System Impact Assessment Report (Addendum)

Northern Ontario Shunt Capacitors

CAA ID 2008-352

November 15, 2011

Figure 2: Revised Hanmer SC22 connection

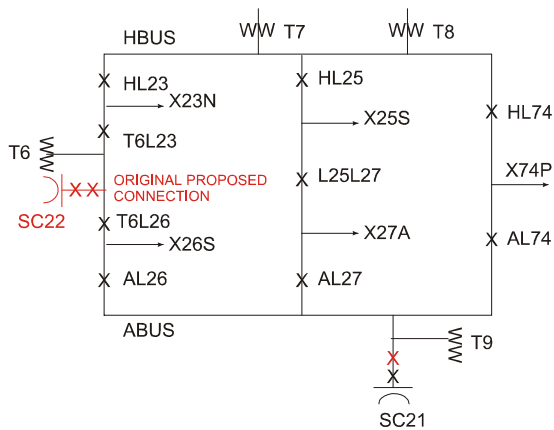
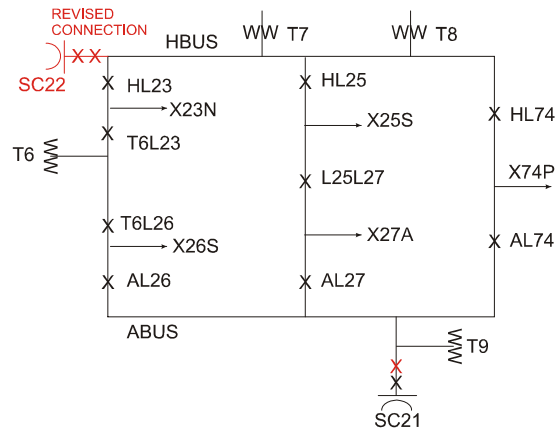
In the original assessment, Hydro One proposed to install a 149 Mvar @ 220 kV capacitor at Hanmer TS, SC22 to be connected between breaker T6L23 and T6L23 as shown in **Figure 1**. The in service of this capacitor was originally planned for December, 2010.

Due to construction limitations, Hydro One has revised its planning specifications and is proposing to install the capacitor on the H bus as shown in **Figure 2**. The in service of this capacitor has now been rescheduled for December, 2011.

From the information provided, our review concludes that the (i) revised Hanmer SC22 connection and (ii) the proposed redesign of the Hanmer reactive switching scheme and the new Pinard and Porcupine reactive switching schemes, subject to the requirements specified in this report will not result in a material adverse effect on the reliability of the IESO-controlled grid.
